# GUAM POWER AUTHORITY

**AMENDMENT NO.: I**

**INVITATION TO BID NO.: GPA-048-18**

**CLARA STREET UNDERGROUND CONVERSION PROJECT**

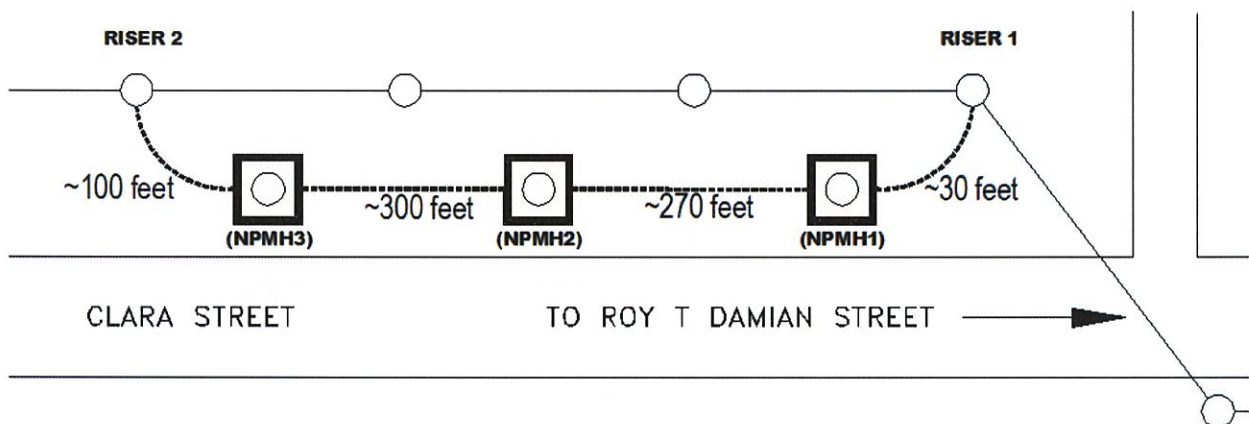
Plans E-2 is not to scale. No distances were indicated on the plan. What is the Total distance of trench work? Provide data for proper estimating.

Is their work on the existing asphalt road? On the routing plan it shows along the grass area.

Please see one-line below for estimated distances. Final distances and manhole locations to be determined upon identification of the Right of Way and final location of the manholes. This shall be coordinated with the Project Engineer during construction.

For this project, there is no planned work on the existing pavement. All trench work and manhole work should be conducted on the shoulder. Any damages to the existing road and/or existing utilities shall be repaired by the contractor at no extra cost to the Authority.
